Product Safety Recall

N202322230 Seat Belt May Not Be Properly Attached

Release Date: January 2021

Revision: 01

Note: The LH side is shown for reference purposes only.

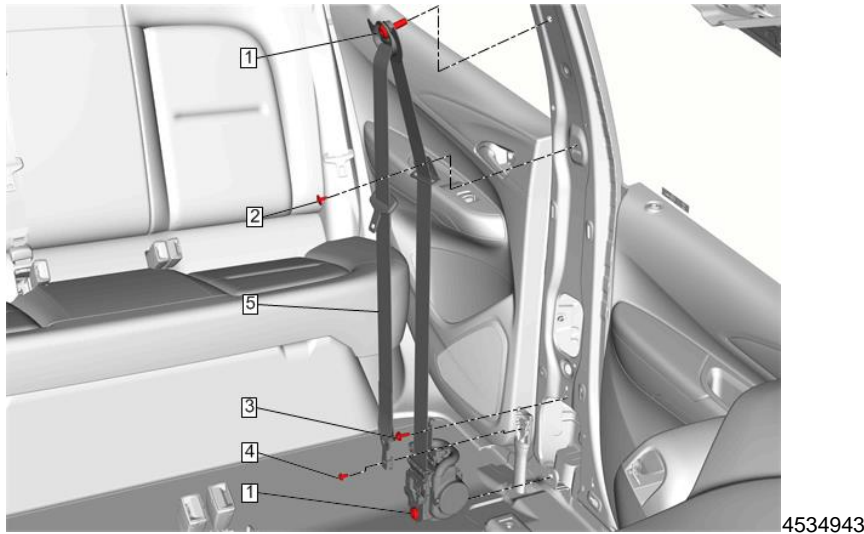
NOTE: The bolt being removed from the vehicle may not have cut the proper threads in the nut when the vehicle was manufactured. If this occurred, expect to feel resistance for the complete bolt length when removing the bolt. When the new bolt is being installed in an unthreaded nut, there will be resistance as the self-threading bolt threads the nut. There will be an initial resistance while the thread is being cut, followed by a reduction in

resistance. This is an expected condition. Continue tightening the bolt until the retractor or belt bracket is secured. To complete the installation, tighten the bolt to the proper torque specification.

2. Remove and discard the lower retractor bolt (1).
3. Install the new retractor mounting bolt. Refer to the note above for installation details. Tighten the new service bolt to 45 N.m (33 lb. ft).
4. Reinstall the center pillar lower trim panel. Refer to *Center Pillar Lower Trim Panel Replacement* in SI.
